**AMENDMENT TO REQUEST FOR
PROPOSAL / MODIFICATION DE
DEMANDE DE PROPOSITION**

Title – Sujet	
Furniture Products	
Solicitation No. – No de l'invitation	Date
1000357679	2021-08-02
Amendment No. - N° modif.	
005	
Solicitation closes – L'invitation prend fin on – le (yyyy-mm-dd) (aaaa-mm-jj)	Time zone – Fuseau horaire
2021-08-19 at – à 2:00 P.M. / 14 h	EDT/HAE Eastern Daylight Time/ Heure Avancée de l'Est
Contracting Authority – Autorité contractante	
Paul Wren 250 Albert Street, Ottawa ON K1P1H1 paul.wren@cra-arc.gc.ca	
Telephone No. – No de téléphone	
613-716-6636	
Fax No. – No de télécopieur	
n/a	
Destination - Destination	
See herein / Voir dans ce document

SOLICITATION AMENDMENT # 005

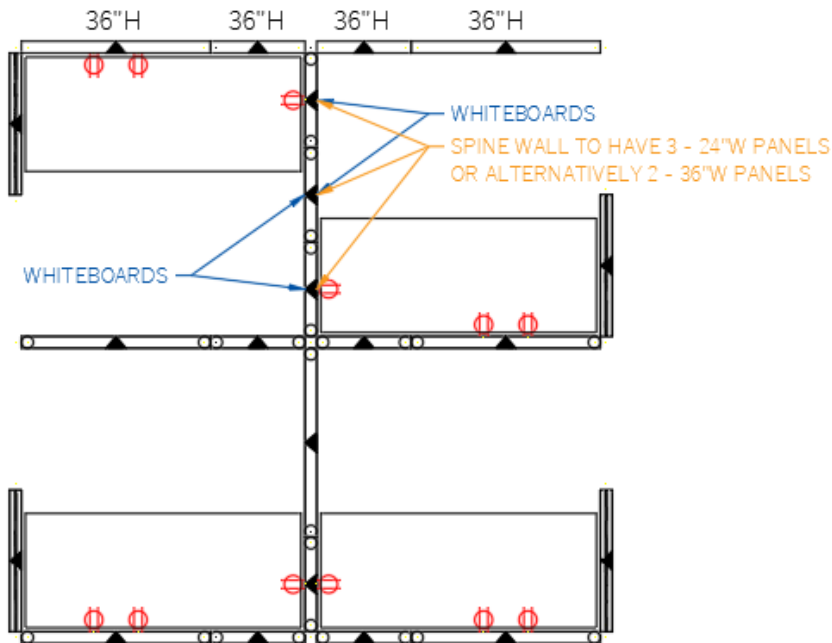
- Q56. 6.5.1.4.12 The panel widths listed contradicts 6.5.1.2.2.4. Please confirm the widths required are the standard sizes of 24", 30", 36", 42", 48", 54" and 60".

- A56. There is no contradiction between 6.5.1.4.12 and 6.5.1.2.2.4. Section 6.5.1.2.2.4 refers to the minimum requirement for the width of panels. Section 6.5.1.4.12 refers to the power receptacles required for different sizes of panels that may be offered.
